City of Madison, Wisconsin

REPORT OF: URBAN DESIGN COMMISSION PRESENTED: January 9, 2008

TITLE: 1601-1739 Thierer Road - Modification to **REFERRED:**

Previously Approved Uniform Sign
Package and Minor Facade Alteration. 17th

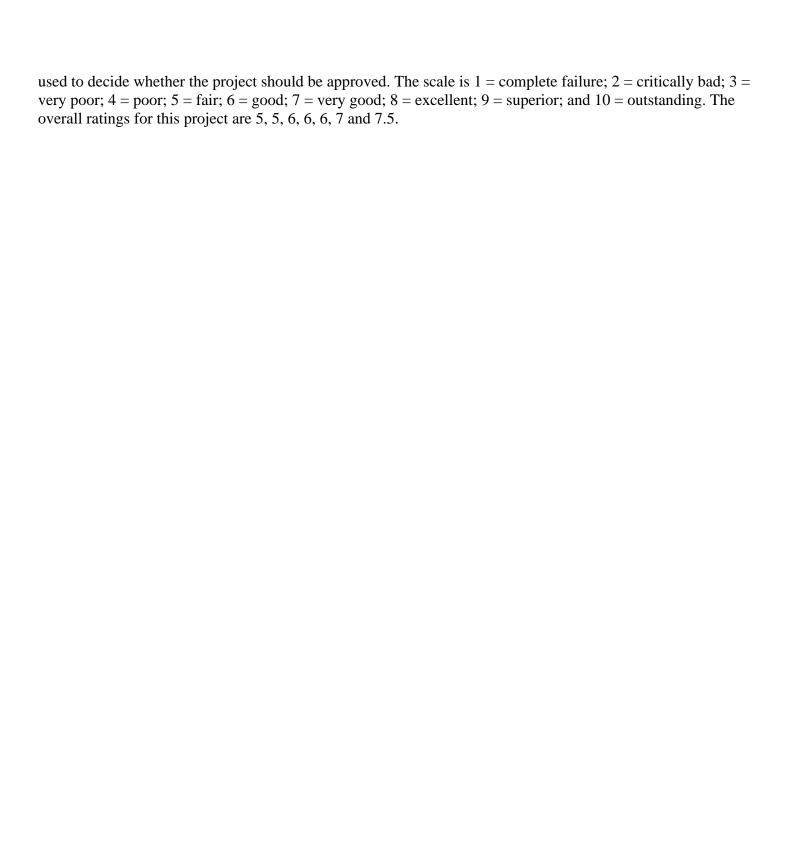
- The cable mounting plates have been moved higher up on the building elevations.
- The face of the canopy has been provided more mass with either an option for 8" or 12" with the mounting height of the canopy raised above an exposed red accent band and one row of block.
- The depth of canopies has been increased from three to five feet from the face of the building with canopies also featuring an extended width.
- A review of the lighting photometric plan was provided which features light fixtures raised above the red horizontal accent band on the building.
- Options for the alignment of cable supports for canopies with underlying window mullions, including an alternative for uniform spacing were detailed.
- Options for connected canopy elements were also detailed.
- A review of details of the uniform sign text was provided.

Following the presentation the Commission noted a preference for uniform location and spacing of the support cables for awnings and improvement on the architecture and design of an existing strip mall.

On a motion by Barnett, seconded by Ferm, the Urban Design Commission **GRANTED FINAL APPROVAL**. The motion was passed on a unanimous vote of (8-0). The motion provided for approval of awnings with support rods spaced evenly per option plan two, with the mounting plate anchors moved up two courses (16"), along with the use of a 12" thick canopy.
